Subject: CHECK ENGINE LIGHT ON WITH DTC P0191:00	Bulletin No: 01-010/14
	Last Issued: 04/08/2014

- This bulletin supersedes the previous bulletins 01-010/14 issued on 04/07/14. The PARTS INFORMATION has been revised.
- Changes are noted below beside the change bar in Red.

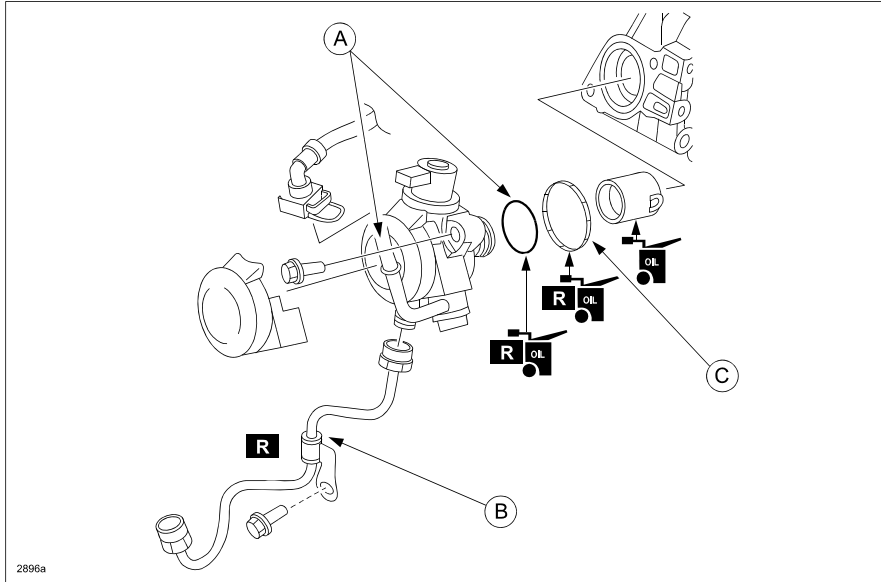
Some vehicles may experience the check engine light on with DTC P0191:00 (Fuel pressure sensor circuit range/performance problem) stored in memory. This is caused by the high pressure fuel pump not generating the target fuel pressure (due to a manufacturing error of the inner parts). To correct the problem, production control has been improved.

1. Verify customer concern.
2. Replace the high pressure fuel pump with a modified one according to the Workshop Manual.
3. Replace the high pressure fuel pump (A: fuel pump; B: fuel pipe; C: rubber seal) with a modified one according to the instructions on MS3 online or the Workshop Manual (section 01-14 HIGH PRESSURE FUEL PUMP REMOVAL/INSTALLATION).

Part Number	Description	Qty.	Notes
PE18-20-3F0	Fuel Pump	1	All models
PE01-13-290D	Fuel Pipe	1	2.0L
PY01-13-290A		1	2.5L
PE01-13-555	Rubber Seal	1	All models
